Southwestern Pennsylvania Road Safety Audit

**Lincoln High School and Hartman, Holy Redeemer &
Northside Elementary Schools**

Ellwood City Borough, Lawrence County, PA

This document represents the final report for the Road Safety Audit conducted around Lincoln High School and Hartman, Holy Redeemer & Northside Elementary Schools in the Borough of Ellwood City, Lawrence County.

Lincoln / Hartman / Holy Redeemer

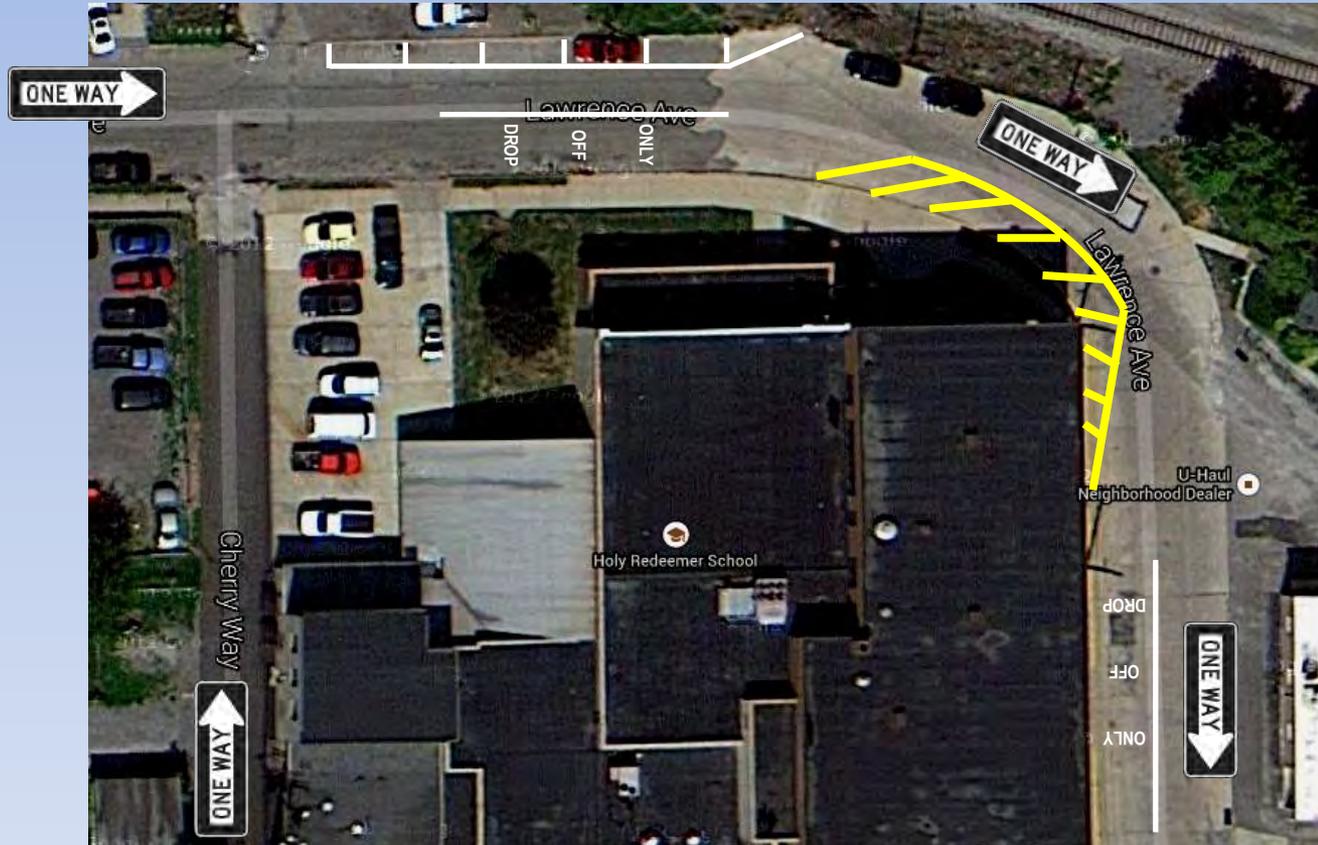
OBSERVATION: The traffic signal at the intersection of 4th Street and Crescent Avenue is outdated. It is pretimed (no vehicle detection), only has 1 signal head per approach, and does not have pedestrian crossing devices. Additional traffic will use this intersection during construction of the 2nd Street bridge. Inefficiencies at this intersection could result in detoured traffic using neighborhood streets to avoid this signal.

SUGGESTIONS:

- Upgrade the 4th & Crescent traffic signal to a modern installation with vehicle detection, countdown pedestrian signal heads and appropriate signage.
- Establish time-of-day signal timing plans to facilitate ingress and egress of buses during peak times.

Lincoln / Hartman

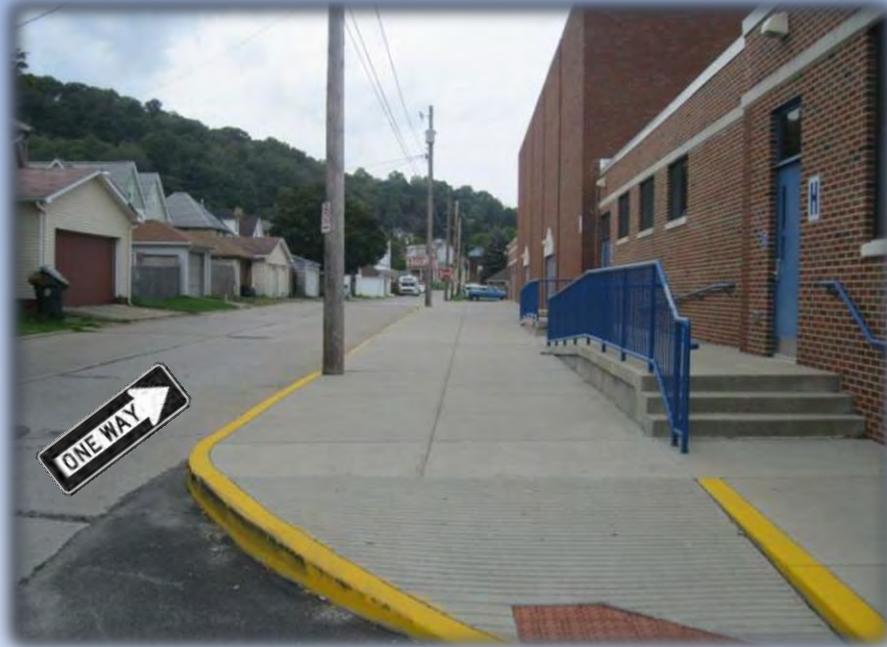
OBSERVATION: Pedestrian scale lighting helps illuminate the sidewalks around parts of the schools. Additional intersection lighting could enhance the visibility of pedestrians at key intersections.

SUGGESTIONS:

- Consider providing an additional overhead street light at the intersection of 5th & Crescent.
- Consider providing intersection lighting at the intersection of Wolverine Avenue & Short Street.

Lincoln

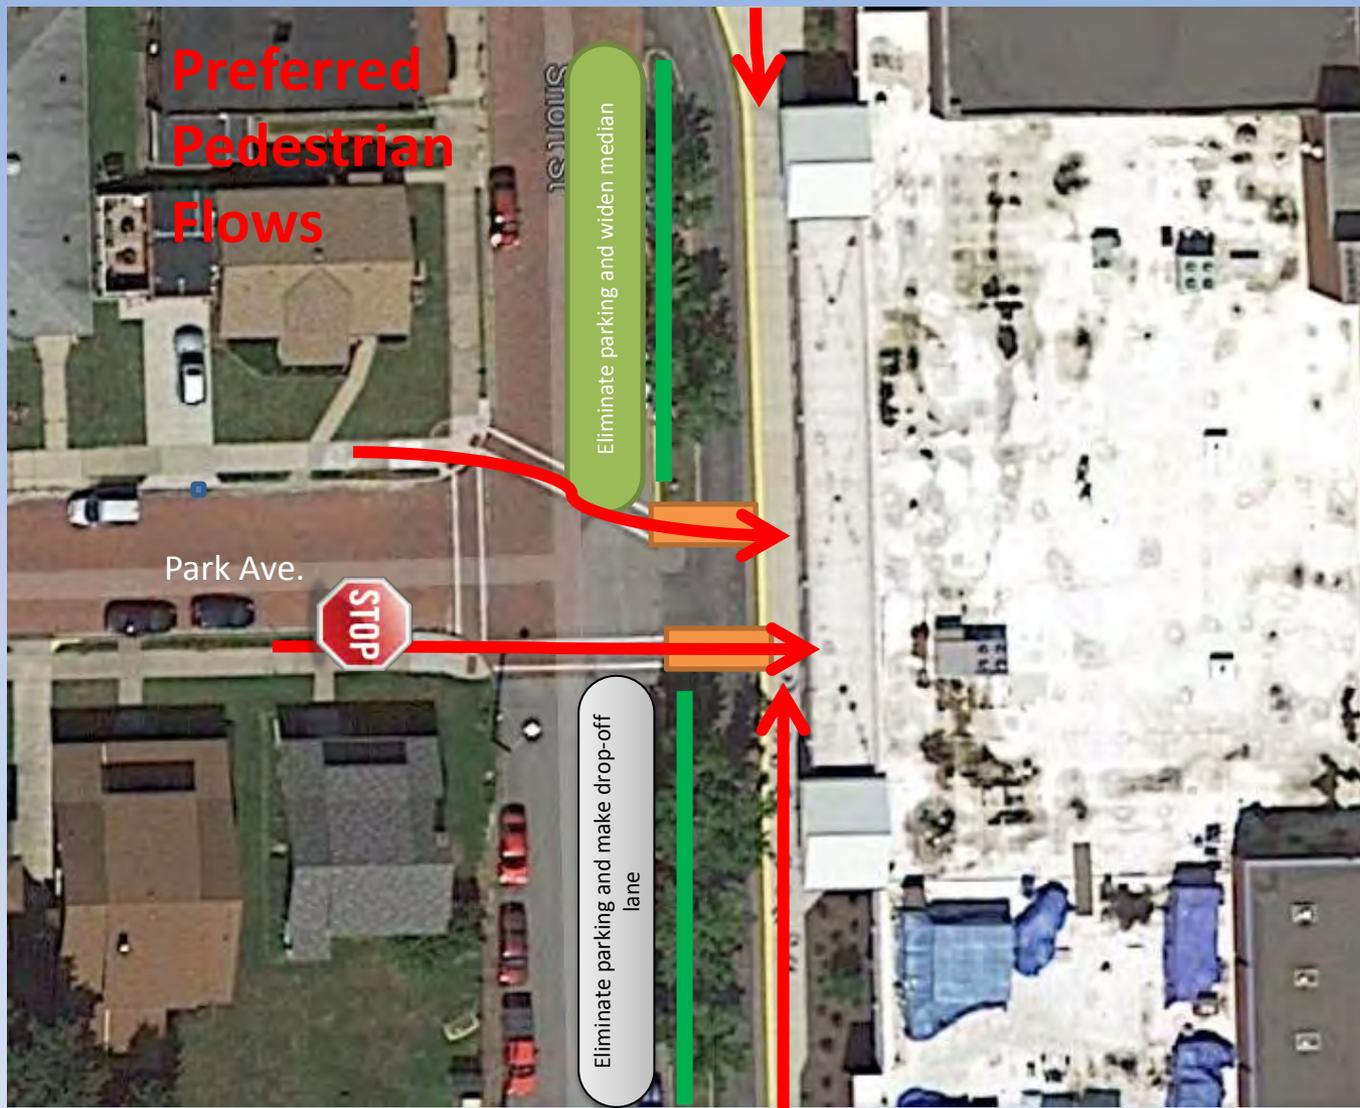
OBSERVATION: There are pedestrian and vehicle conflicts on Short Street due to uncontrolled pedestrian crossing areas and inconsistencies in student pick-up and drop-offs. Bus-pedestrian conflicts were particularly evident at the north end of the school driveway. There is no EB STOP sign on Park Avenue at this location.

- SUGGESTIONS:**
- Install a STOP sign on Park Avenue.
 - Prohibit parking on Park Avenue near the intersection with Short Street in order to increase the visibility of pedestrians.
